**Finding of No Significant Impact (FONSI)**

**Record of Decision (ROD)**

**Agency Concurrence Letters, Public Comment Letters and Responses  
to Comments, and Environmental Assessment Errata**

**For the North Texas Optimization of the Airspace and Procedures in  
the Metroplex (North Texas OAPM)**

**Figure 5a:** Radar tracks of arrivals to DAL over ADS, showing 78 of 185 arrivals penetrating the ADS Class D airspace. **Figure 5b:** Another image of DAL arrivals over ADS, shown against a Terminal Area Chart.

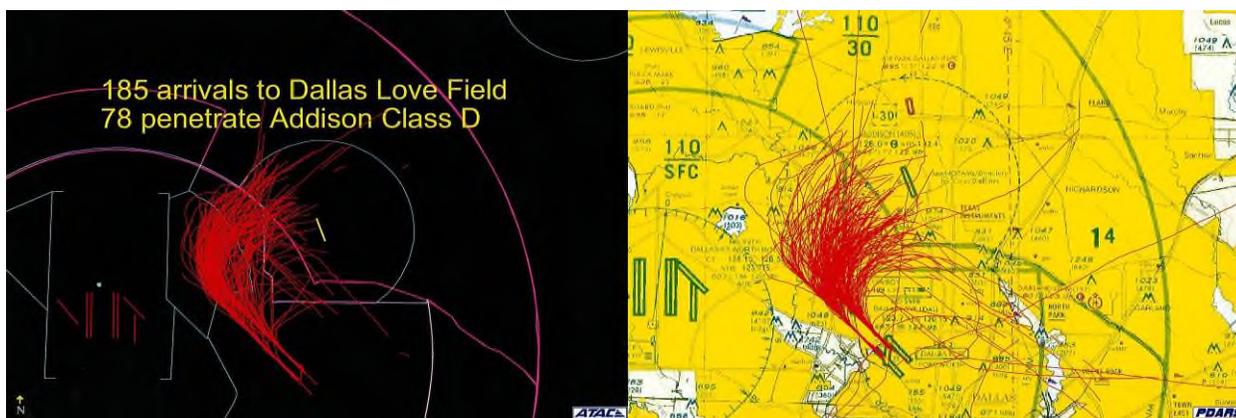
Figures 5a and 5b show the radar tracks of arrivals to Runways 13L and 13R at DAL passing over ADS. The tracks start as the aircraft descend through 3,000 MSL. As is clear from these figures, the overwhelming majority of aircraft approaching DAL do not descend below 3,000 MSL (below the existing DFW Class B floor) until crossing WEST

of Addison's runway. This supports the idea that limiting expansion of the Class B airspace to an arc passing over Addison's runway is sufficient to contain the approaches into Dallas Love Field.

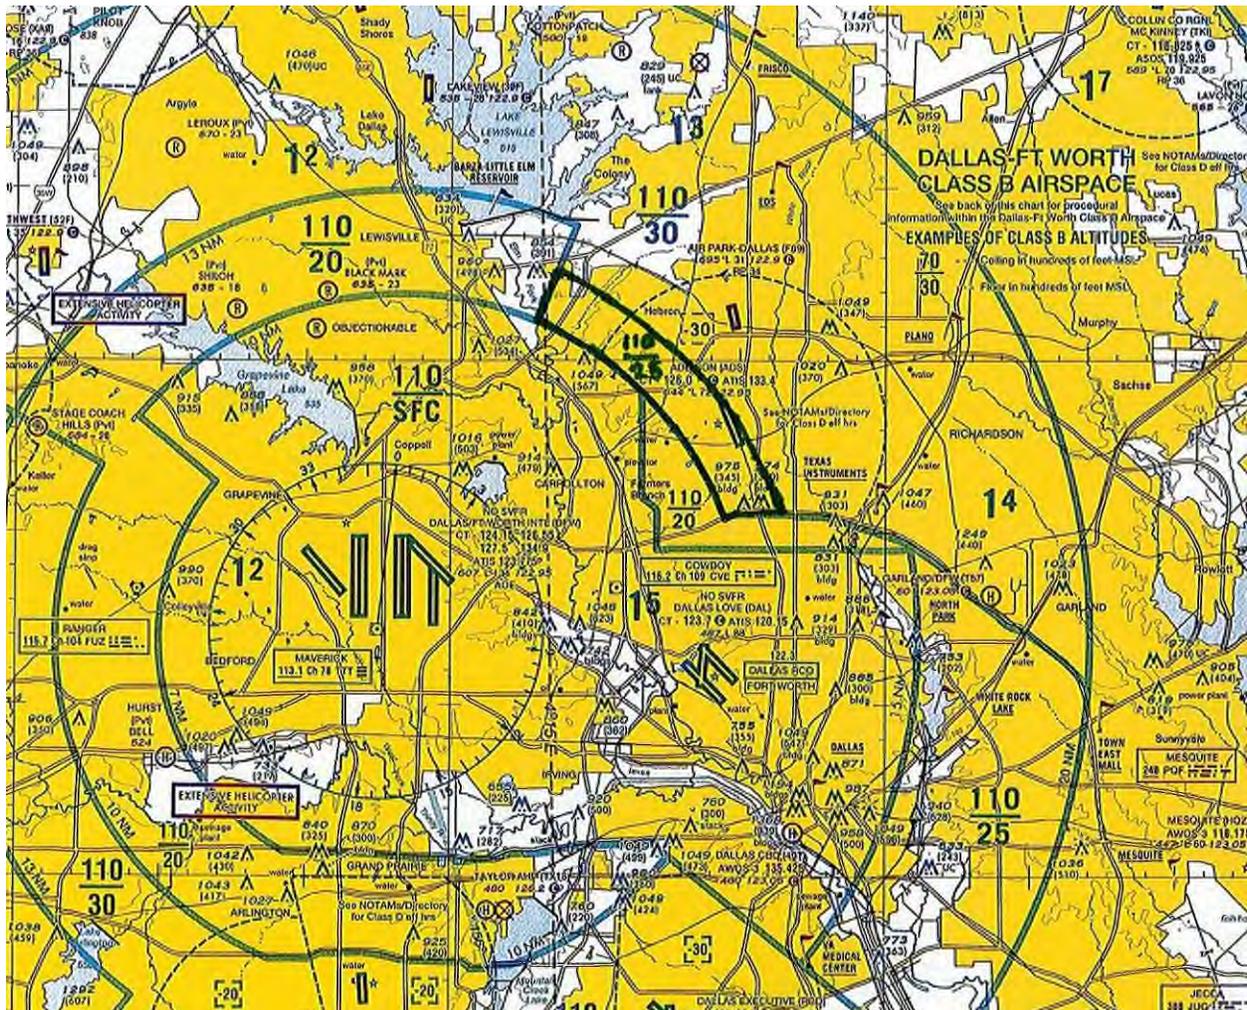
Addison's proposed alternative limiting expansion of the DFW Class B over ADS includes setting the outer arc at 11.5 NM.

Figure 6 illustrates Addison's proposed alternative to limit the expansion of the DFW Class B over ADS to an area between the 10-NM and 11.5-NM arcs. This proposal is consistent with the recommendation of the Ad Hoc Committee and sufficient to contain the DAL approaches. Furthermore, it provides excellent, easily-identified landmarks to aid VFR pilots in identifying the boundaries of the Class B airspace: the Galleria (a cluster of tall structures) at the south end; Addison's runway in the center; and a large landfill at the northern end of the 11.5-NM arc. As stated in the NPRM, "FAA agrees that

Exhibit 4-4

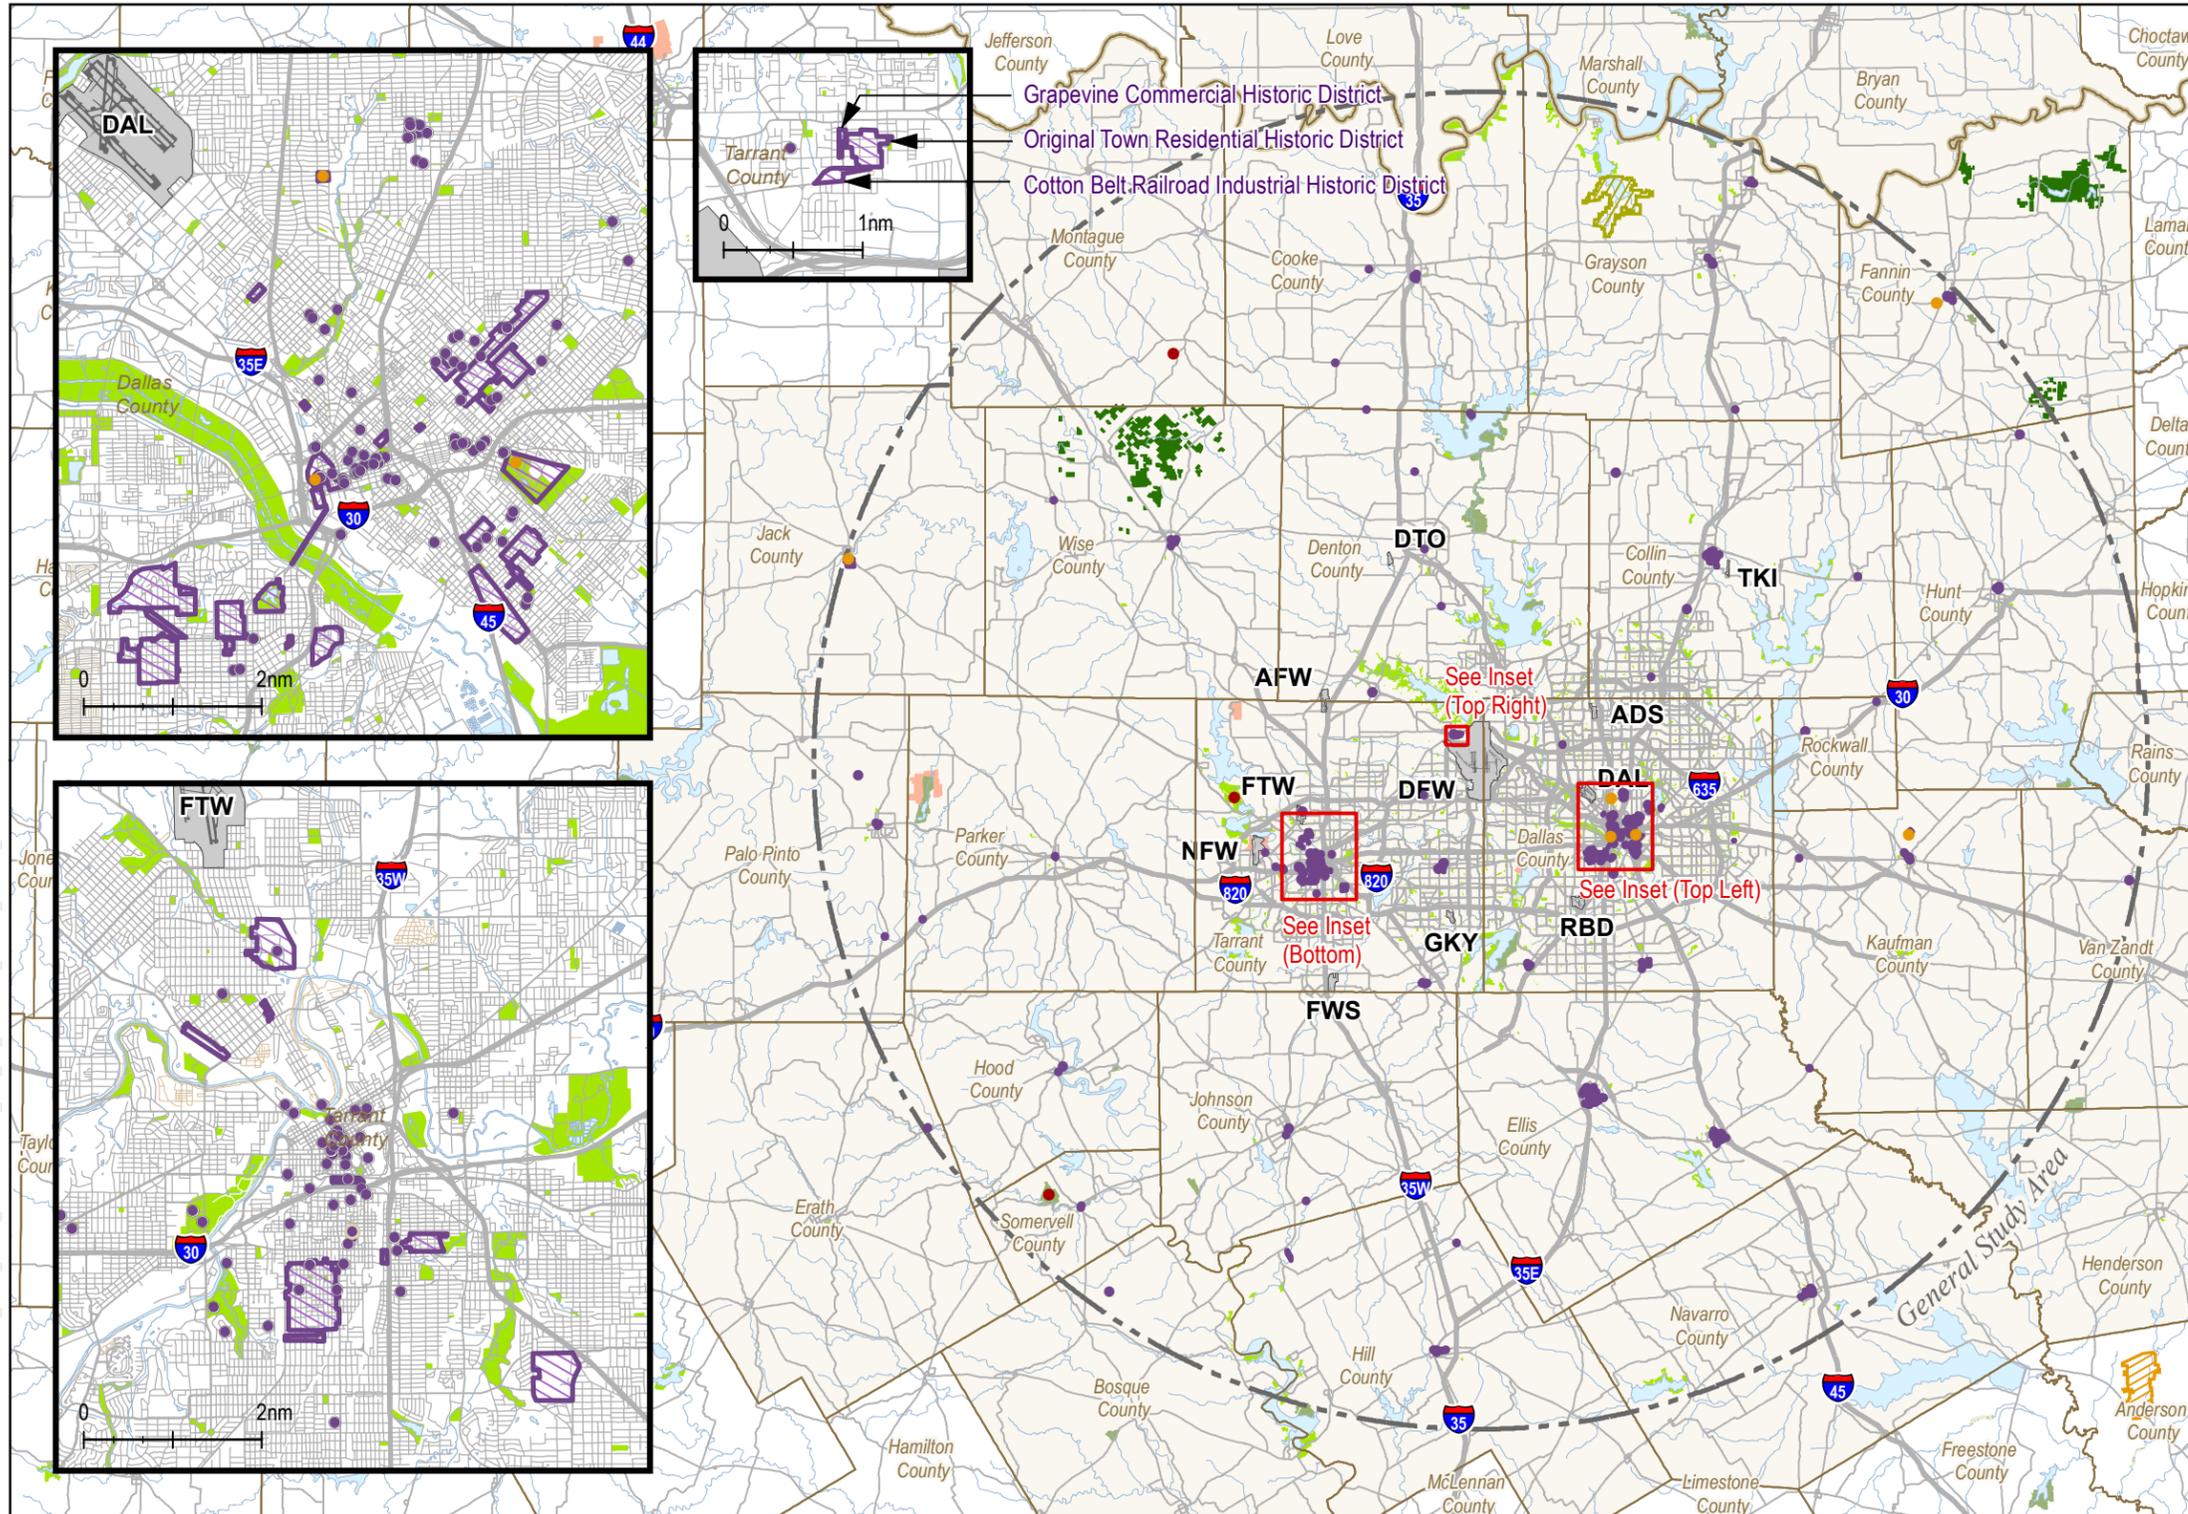
- Exhibit 4-4:
  - The three areas identified in the legend as National Parks are not NPS units. Caddo National Grassland and Lyndon B. Johnson National Grassland are managed by the US Forest Service and Sheppard AFB Recreation Area is managed by the DOD, these areas need to be correctly noted as such.
  - Dinosaur Valley NNL needs to be added to this map given that it falls within the GSA and is identified in Appendix F.

On page 4-139, Exhibit 4-4 will be corrected in response to a National Park Service comment (email: T. Whittington Nov 20, 2013):

- Caddo National Grassland was listed as a National Park and is corrected to US Forest Service.
- Lyndon B. Johnson National Grassland was listed as a National Park and is corrected to US Forest Service.
- Sheppard AFB Recreation Area was listed as a National Park and is corrected to Department of Defense.

- Dinosaur Valley was listed as a State Park and is corrected to a National Natural Landmark.
- Several State Parks will change identification number in the Exhibit. Identification numbers 10 through 16 will be corrected to 9 through 15 respectively; the data source will be corrected

NP4	<b>Page 4-136, Table 4-4:</b> The first property type listed is "Historic Sites", delete the reference to the "National Registry of Natural Landmarks."	Comment noted. Requested correction accepted and included in the errata.
			NP5	<b>Exhibit 4-4:</b> The three areas identified in the legend as National Parks are not NPS units. Caddo National Grassland and Lyndon B. Johnson National Grassland are managed by the US Forest Service and Sheppard AFB Recreation Area is managed by the DOD, these areas need to be correctly noted as such. Dinosaur Valley NNL needs to be added to this map given that it falls within the GSA and is identified in Appendix F.	Comment noted. Requested correction accepted and included in the errata.

Path: H:\GIS\USAITX\305220\_North\_Texas\_OAPM\305220\_NTx\_EA\_Exhibit4-5\_Historic\_Cultural\_Resources.mxd

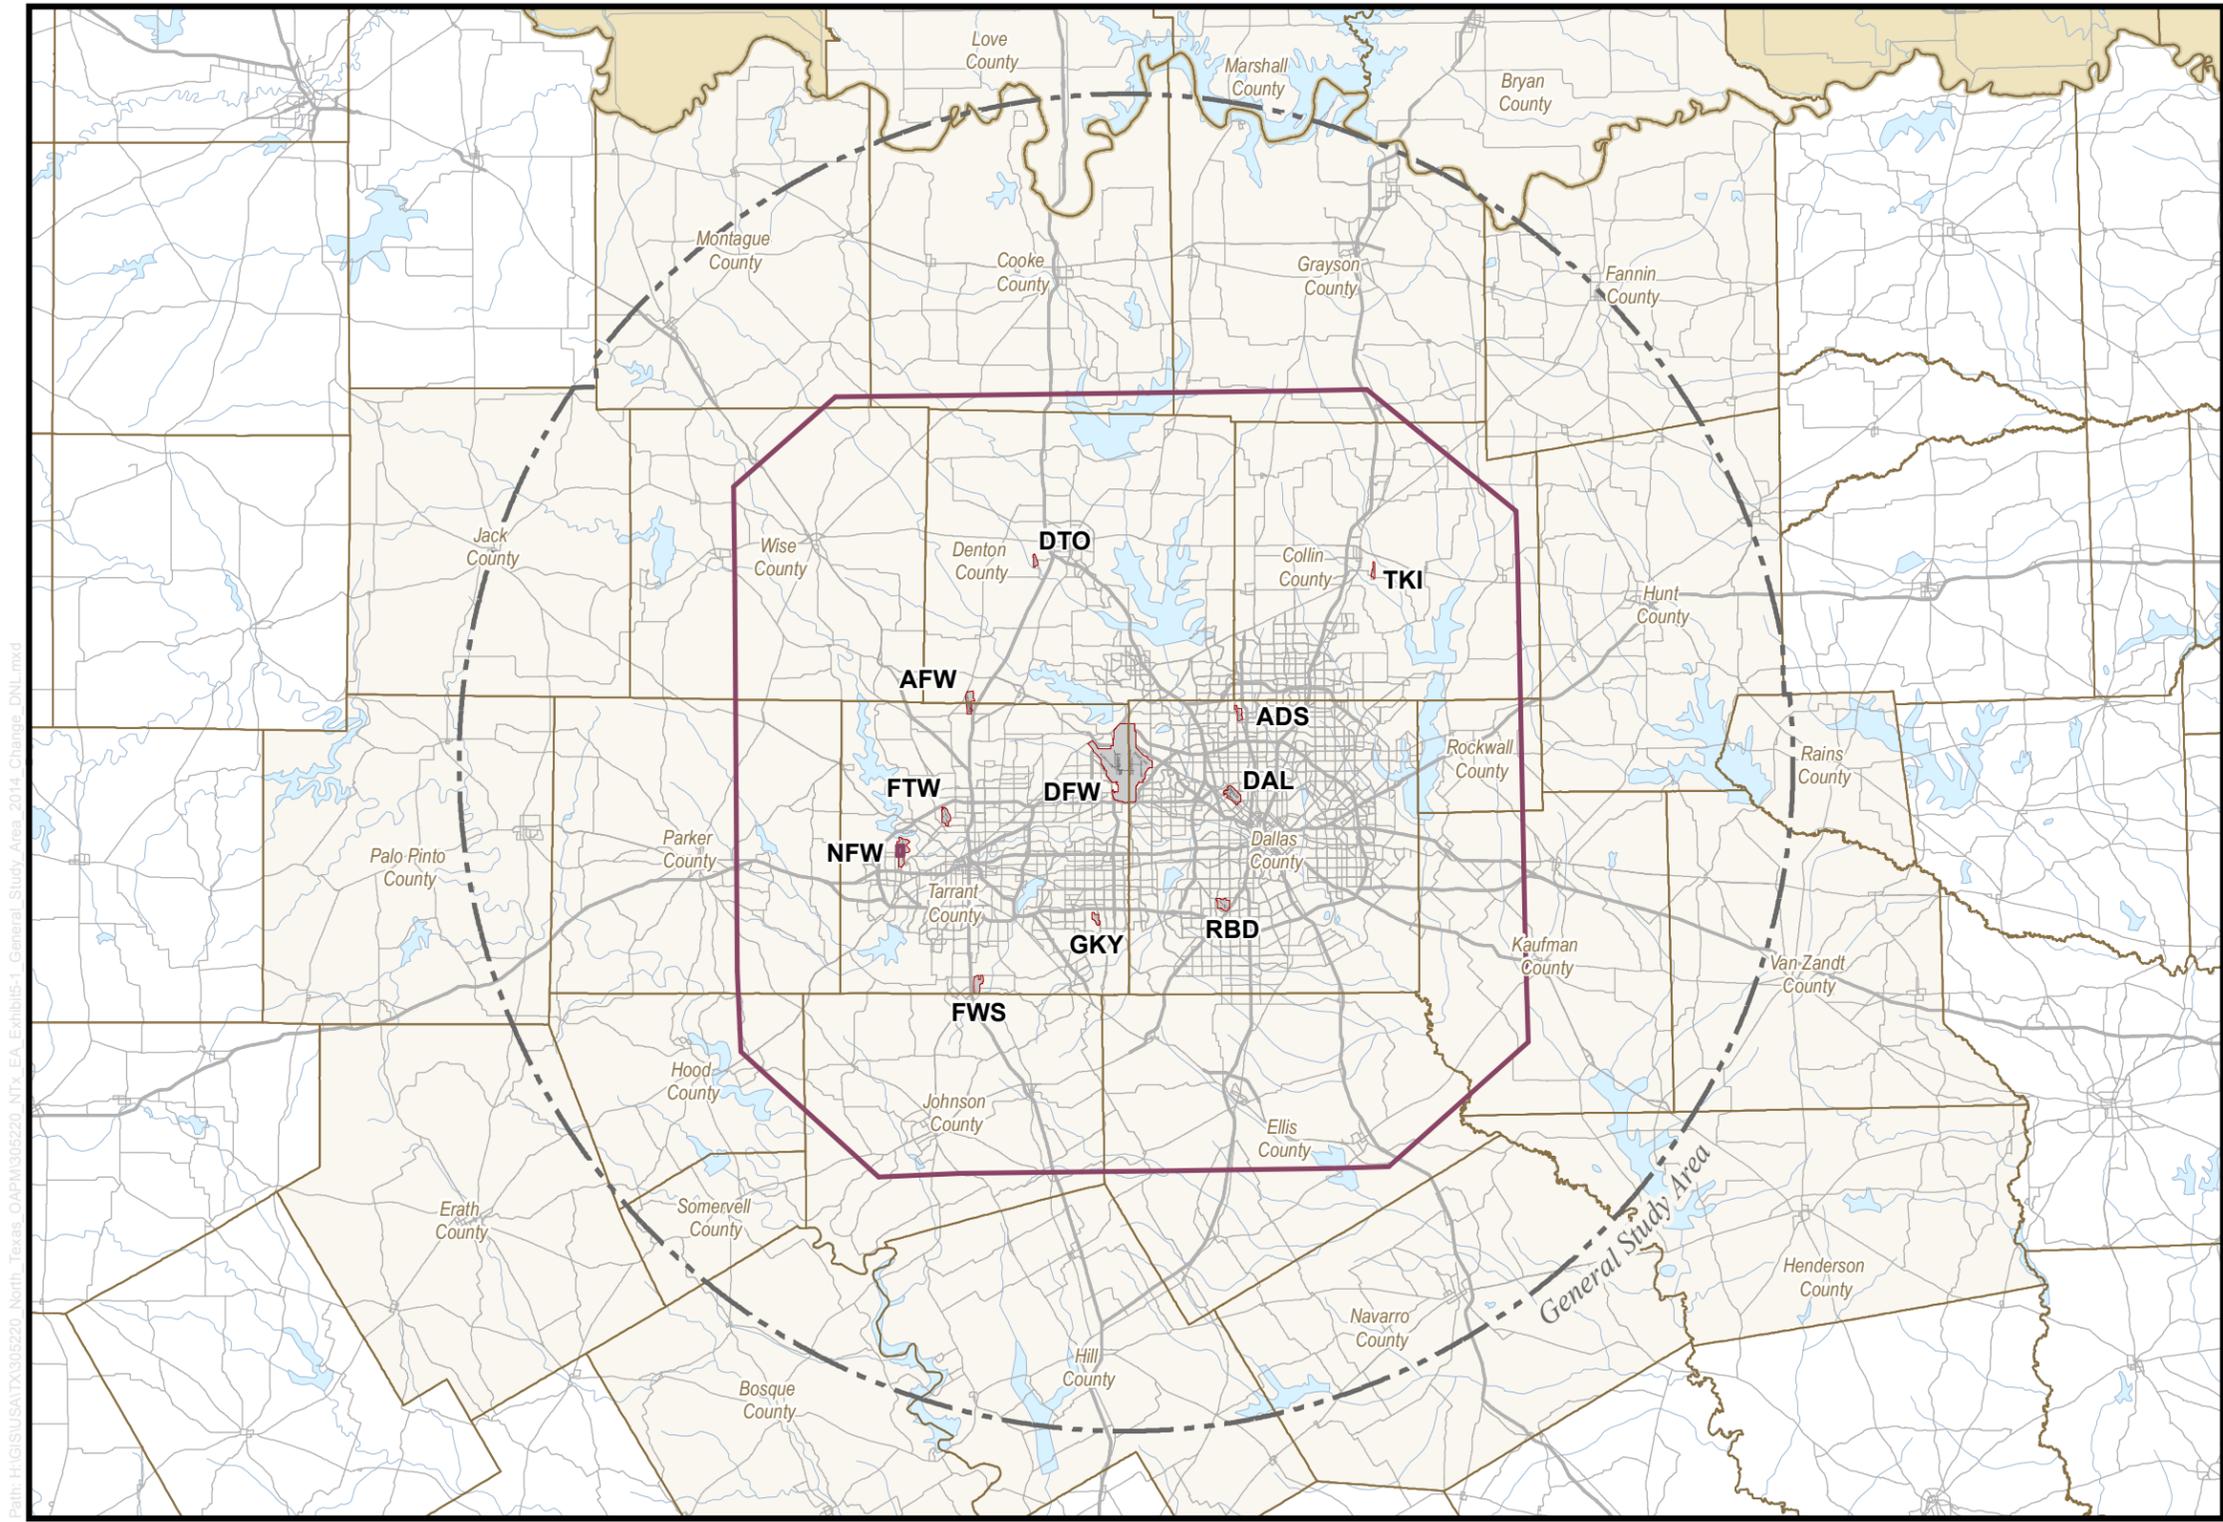
- Exhibit 4-5:
  - Change the map title to "Historical, Cultural and Natural Heritage Resources" for consistency with the above recommended changes.

On page 4-141, Exhibit 4-5 the data source will be corrected in response to a National Park Service comment (email: T. Whittington Nov 20, 2013):

NP6	<b>Exhibit 4-5:</b> Change the map title to "Historical, Cultural and Natural Heritage Resources" for consistency with the above recommended changes.	FAA did not change the section title of Exhibit 4-4 for consistency with FAA Order 1050.1E (specifically, FAA Order 1050.1E organizationally groups National Natural Landmarks with Historic and Cultural Resources).
			NP7	<b>Several sites in Appendix F</b> are incorrectly listed as National Natural Landmarks. All of following sites need to be changed to a National Historic Landmark: Page F-11, Dealey Plaza Historic District Page F-13, Fair Park Texas Centennial Buildings Page F-14, Fort Richardson Page F-17, Highland Park Shopping Village Page F-34, Porter Farm Page F-37, Rayburn Samuel T. House	Comment noted. Requested correction accepted and included in the errata.
none	Karen Burton	11/19/2013	KB2	Why can't FAA implement noise abatement procedures for Southlake?	<p>The commenter's question pertains to current operations and existing procedures for Runway 31L at DFW. It is important to note that the proposed OAPM project, if approved, would not be implemented until the fall of 2014.</p> <p>Existing procedures are designed to meet applicable safety and design standards and are optimized for the current operating configuration at DFW. FAA continues to operate within the parameters set by the DFW Runway Use plan.</p> <p>The objective of the North Texas OAPM project is to improve the flexibility and predictability of air traffic routes in the North Texas Metroplex by increasing the use of PBN technology. As discussed in Section 2.2 of the Draft EA, the purpose of the North Texas OAPM project is to take advantage of the benefits of performance based navigation by implementing RNAV procedures that will help improve the efficiency of the airspace in the North Texas Metroplex.</p> <p>The purpose of the North Texas OAPM project is not to abate existing aircraft noise issues associated with current operations at North Texas Metroplex airports. However, the potential for environmental impacts, including noise related to implementing the Proposed Action, is assessed in the Draft EA; the project does not propose any procedures that would result in significant or reportable noise impacts. See Chapter 5 Environmental Consequences of the Draft EA and the Aircraft Noise Technical Report for discussion of the noise analysis and the potential environmental impacts associated with implementation of the North Texas OAPM project.</p>
